**Remedial Investigation
and Feasibility Study
Work Plan Addendum**

26 September 2013

Glacier Northwest, Inc. – Reichhold, Inc. Site

5900 West Marginal Way SW
Seattle, Washington 98106

Figure 1

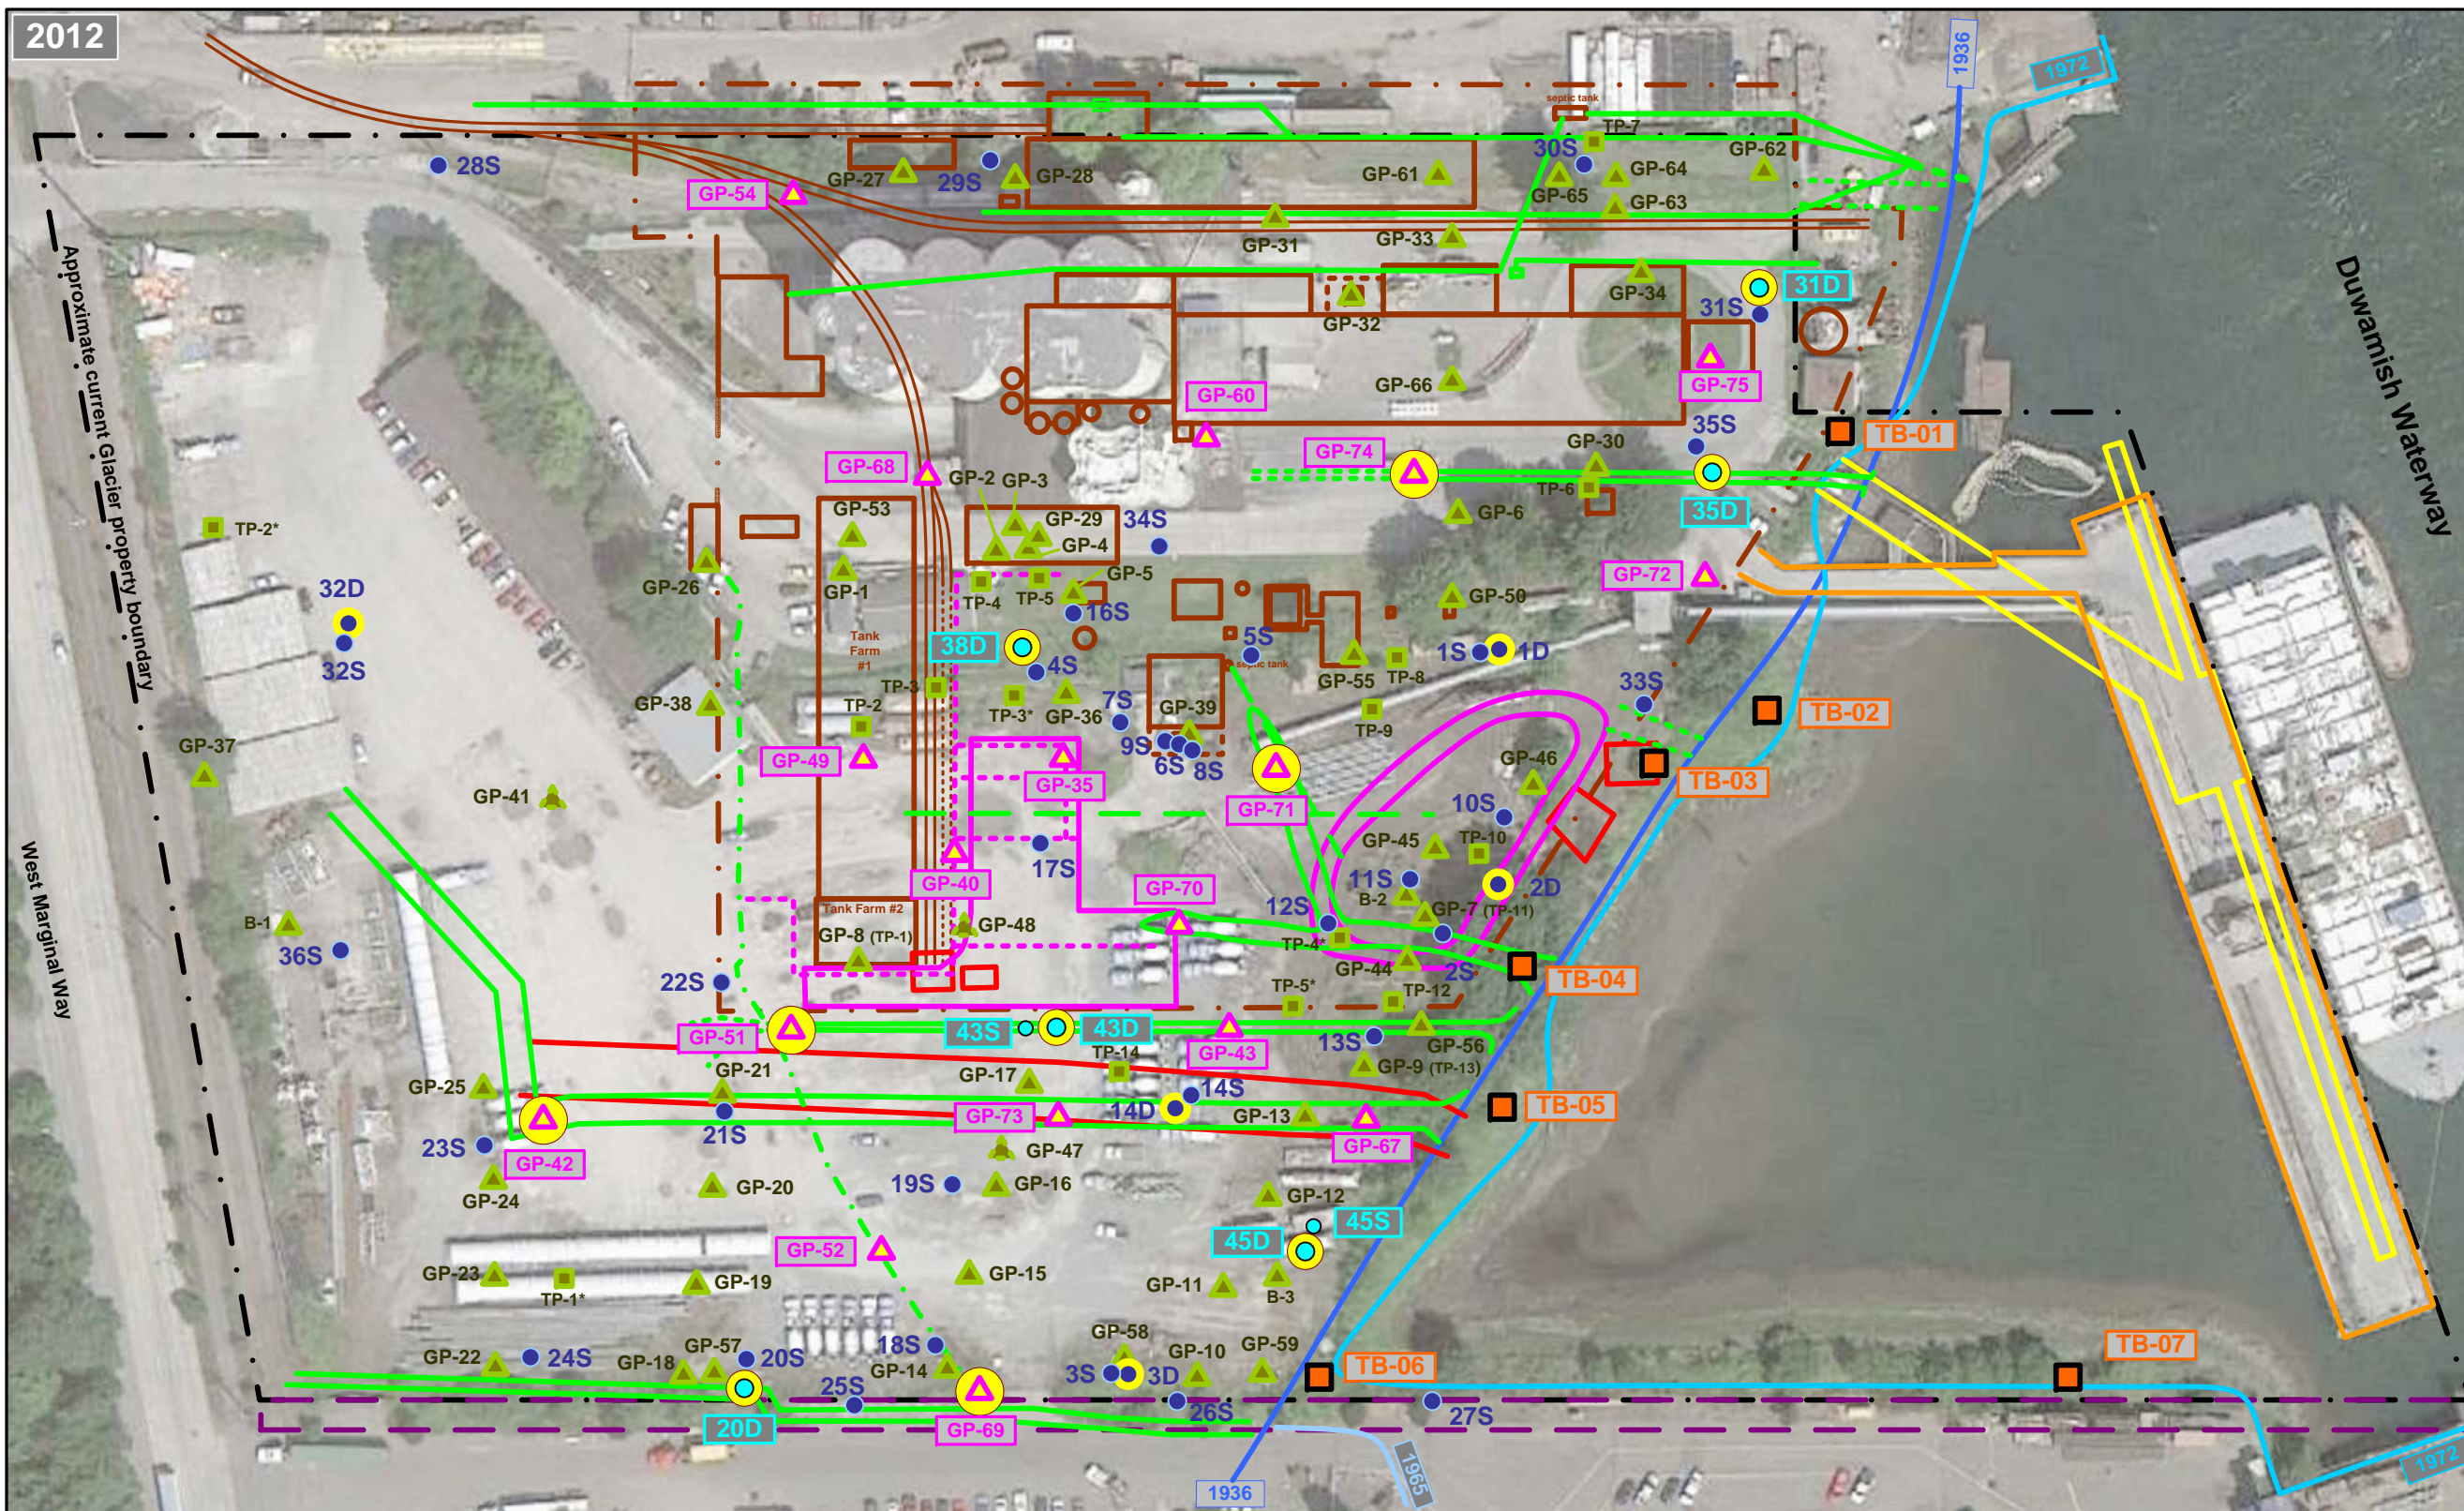
- Figure 1 provides an overview of historical sampling locations (test pits, borings, and wells), historical site features, and the remaining RI sample boring and well locations. Figure 1 replaces Figures 2 and 4 in the August 2012 Work Plan.

Figure 2

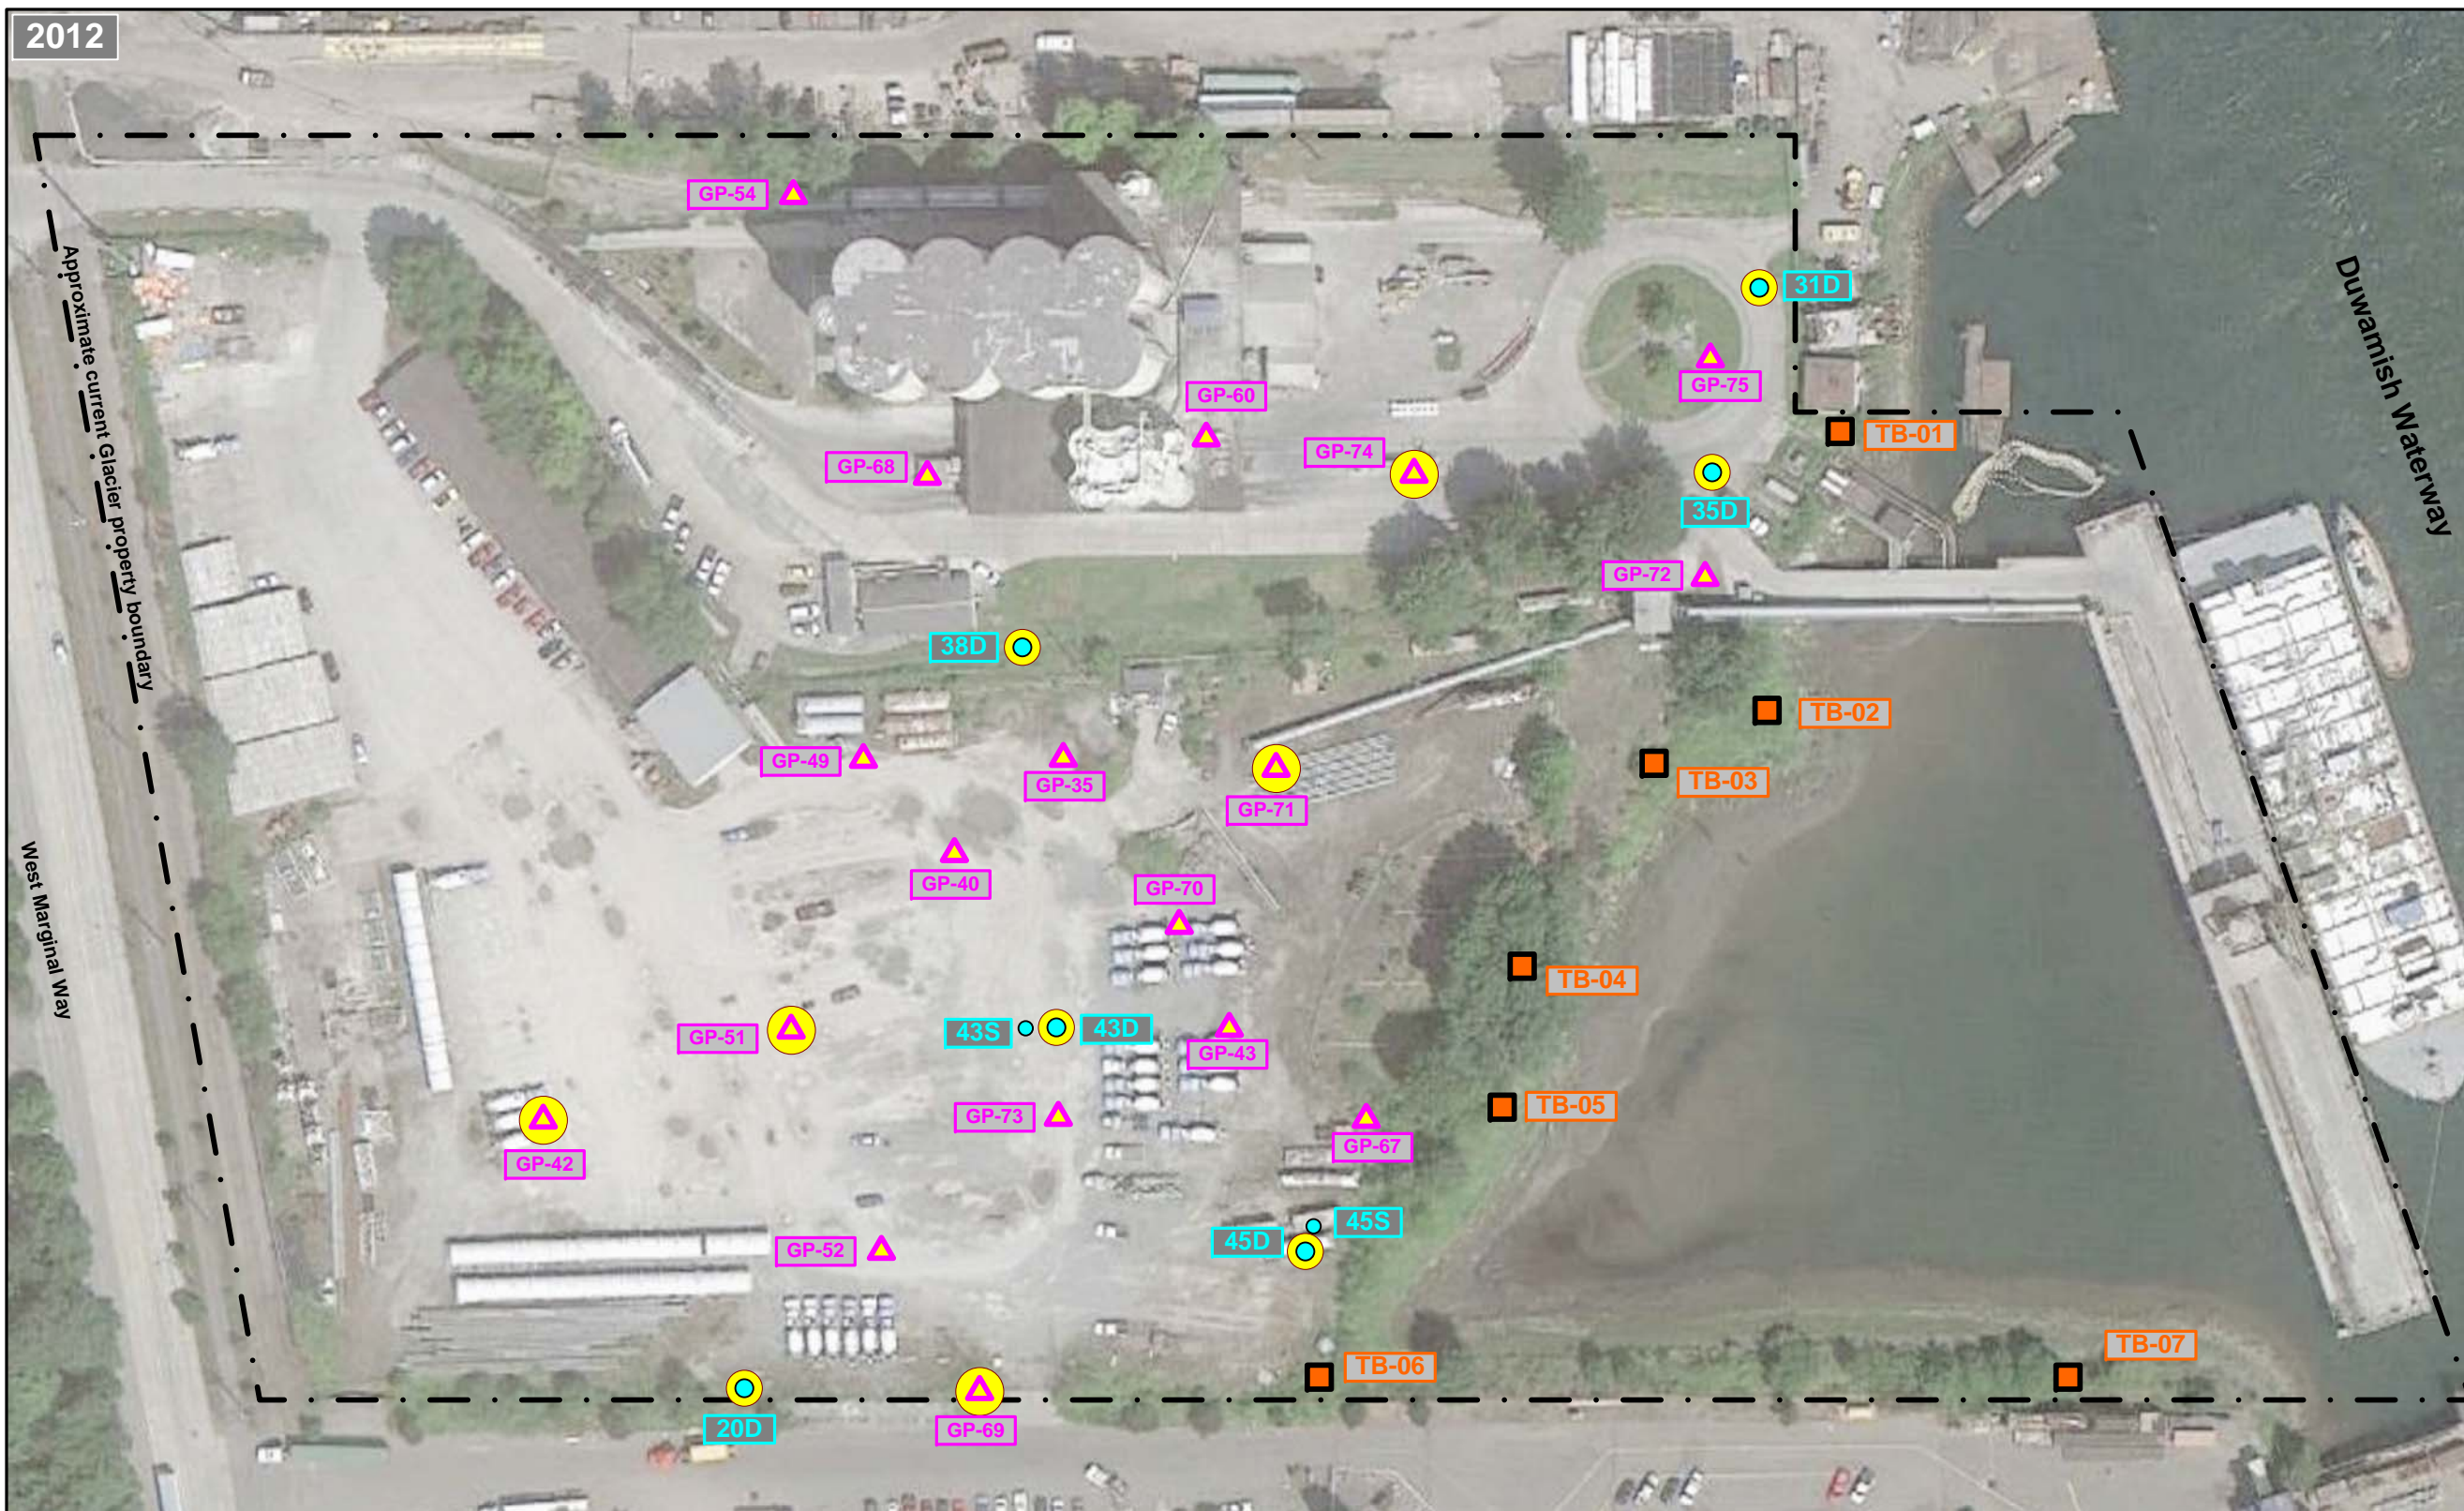
- Figure 2 depicts the locations of the new soil borings and monitoring wells on an aerial photo background. Figure 2 replaces Figure 7 in the August 2012 Work Plan.

Figure 3

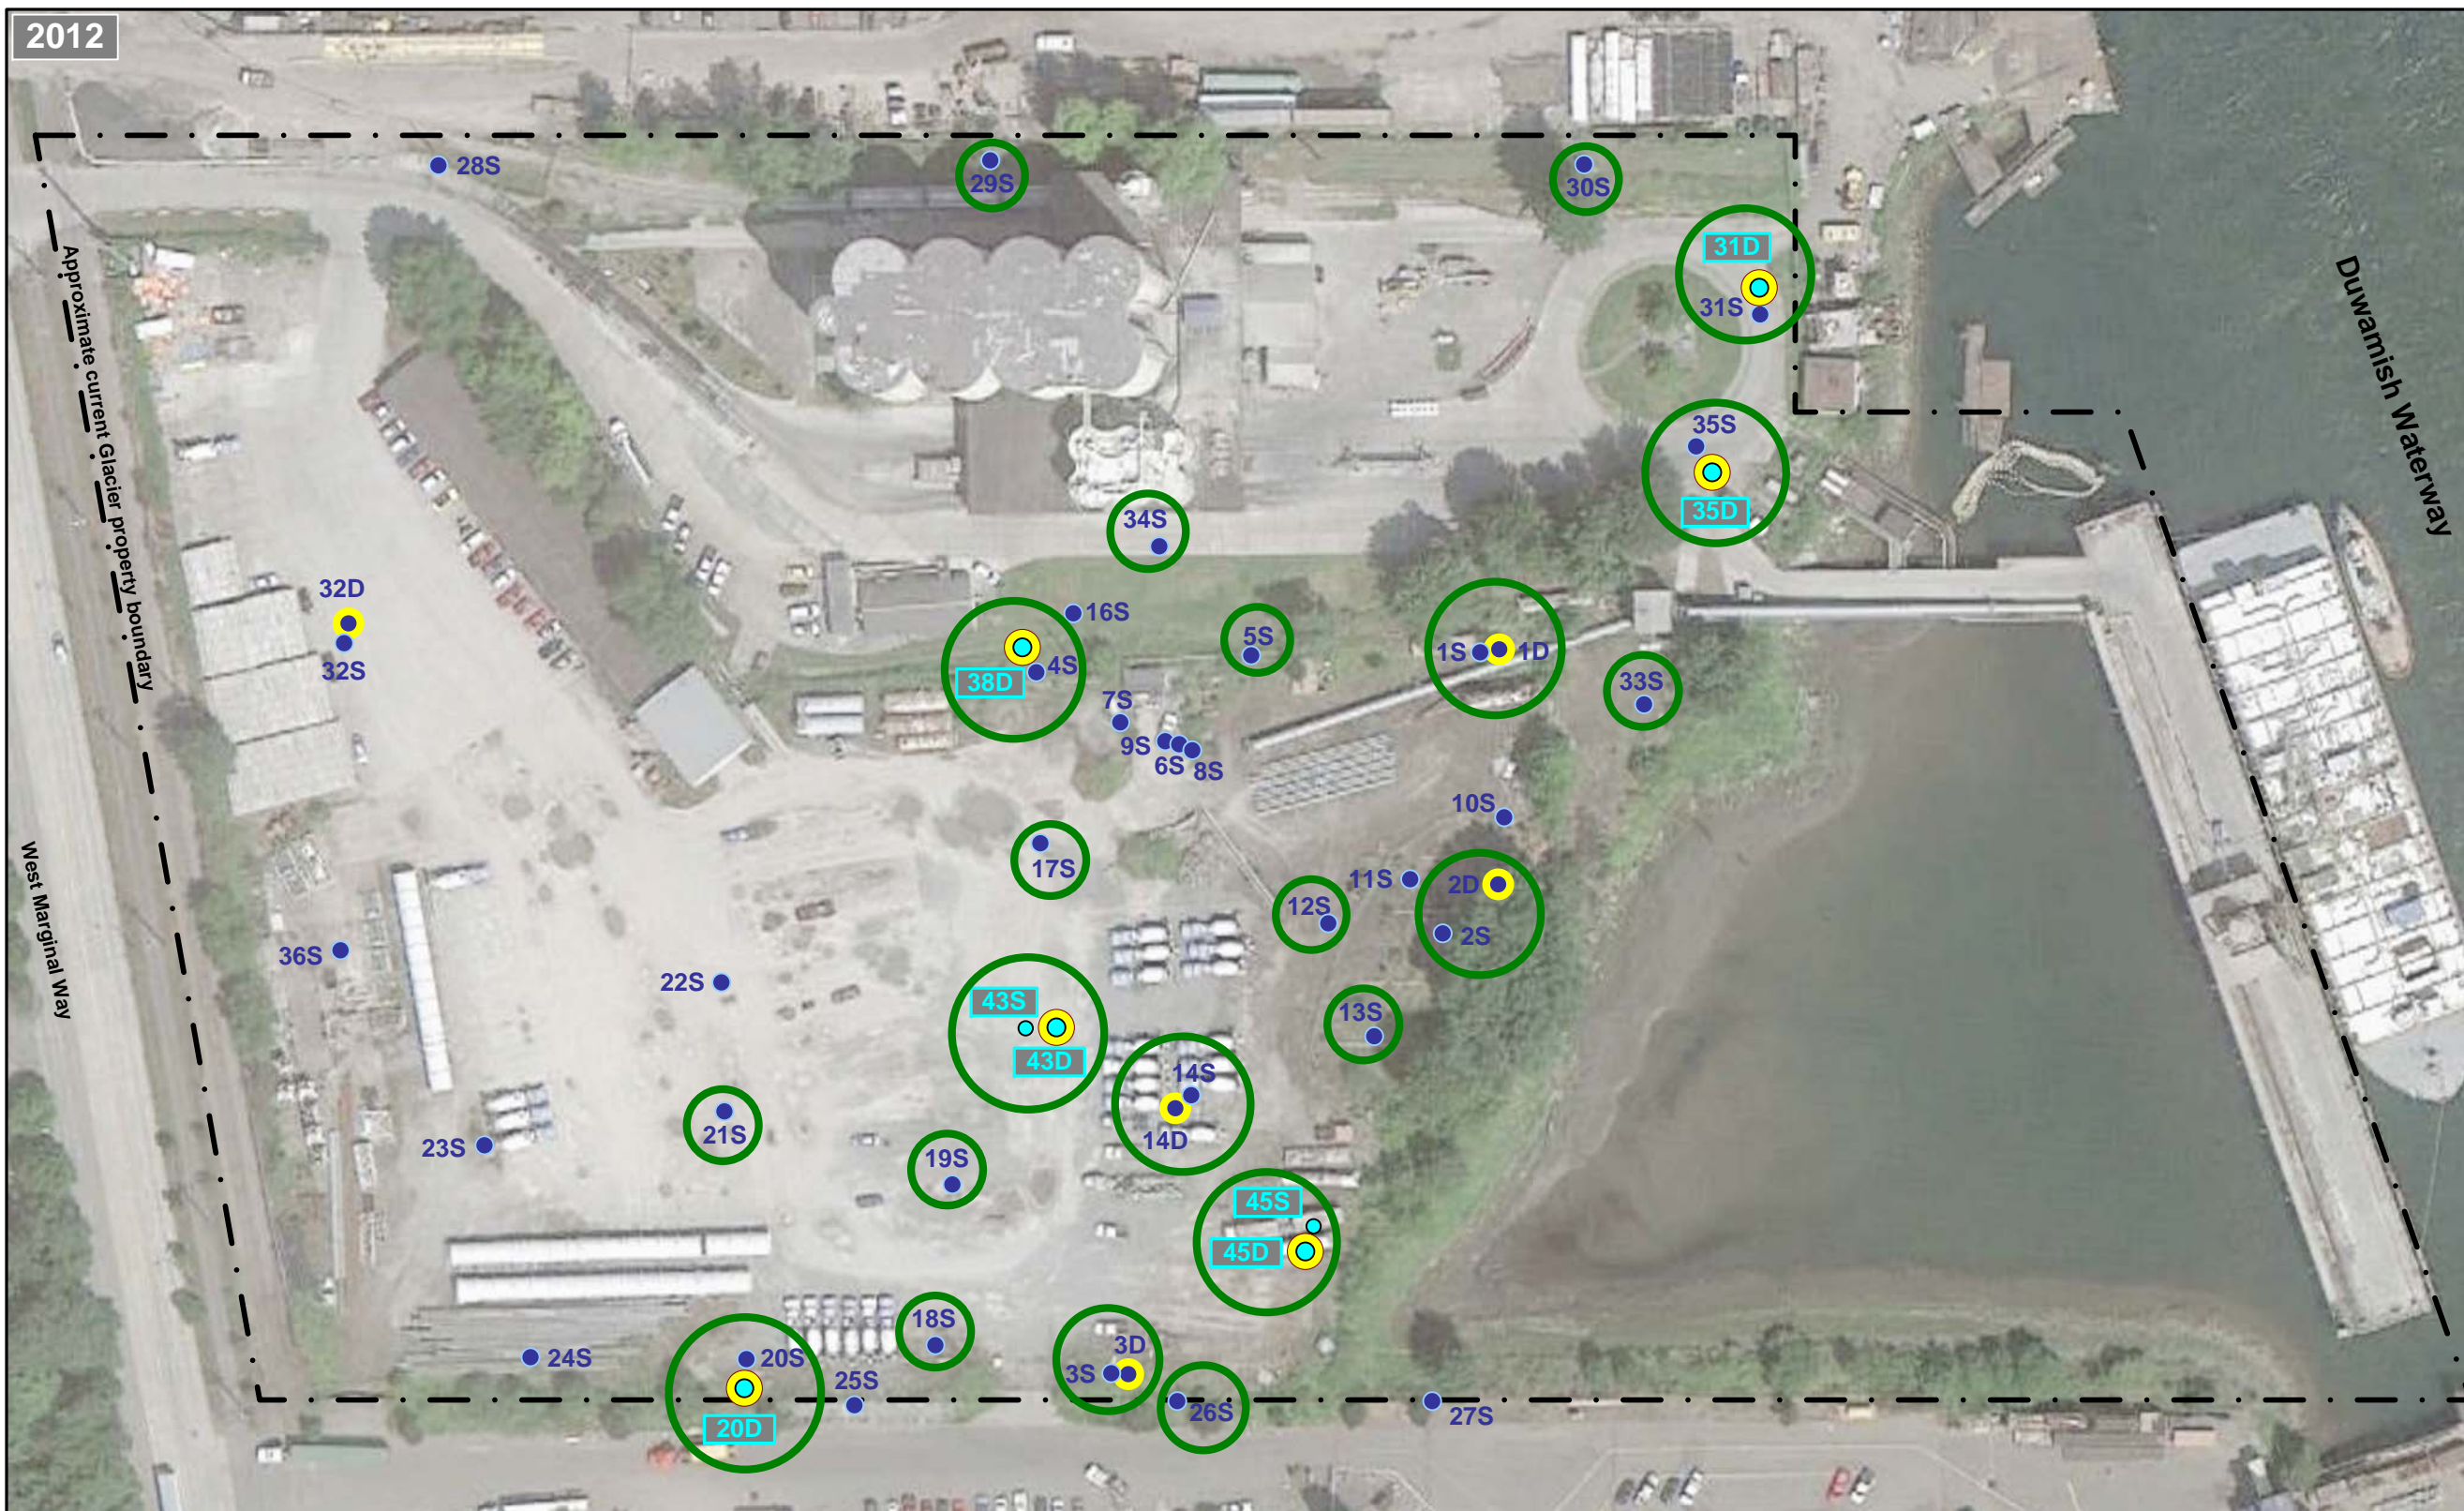
- Figure 3 shows the locations of existing and new monitoring wells and indicates which wells are to be included in the semi-annual monitoring events and quarterly water level elevation monitoring.
